UNITED STATES PATENT AND TRADEMARK OFFICE

**Advisory Action
Before the Filing of an Appeal Brief**

10/750,906

RIETJENS, PETER WILHELMUS
HENRICUS

FIG.-1

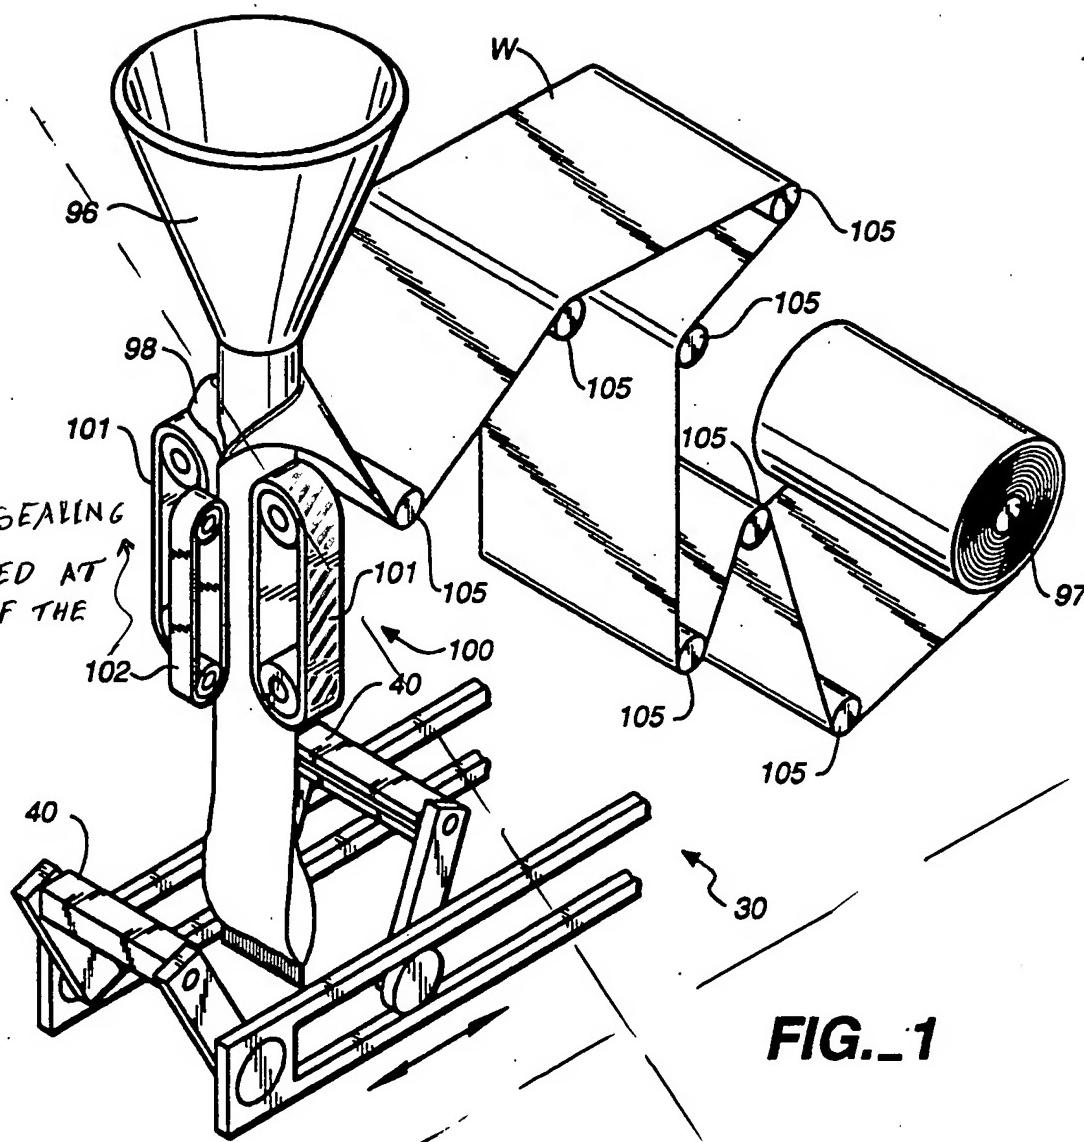
Continuation of 11. does NOT place the application in condition for allowance because: the examiner still believes that Fukuda's patent '098 discloses the claimed limitations of transverse sealing jaws that are movable in a vertical plane (Figs. 11a, 11b via sealing jaw 40 moving vertically and Figs. 14a-14c) perpendicular to a front side of the machine (Fig. 1; via by considering the front side of the machine as facing the width of belt 101); first longitudinal sealing means (via 102) that are positioned at a first side/lateral side of the form-fill tube (Fig. 1; via 102 positioned at lateral side with respect to fill tube 96). Alternatively, the exact location of stations in respect to another is a matter of engineering design choice, as long as the reference discloses the claimed stations and using the stations for the same purpose as the claimed invention.

Continuation of 13. Other: Fig. 1 of Fukuda's patent '098 with clarifying the front side of the machine in respect to the movement of the transverse sealing jaws.

MOVEMENT OF
TRANSVERSE SEALING
JAW \perp TO FRONT SIDE

FRONT SIDE
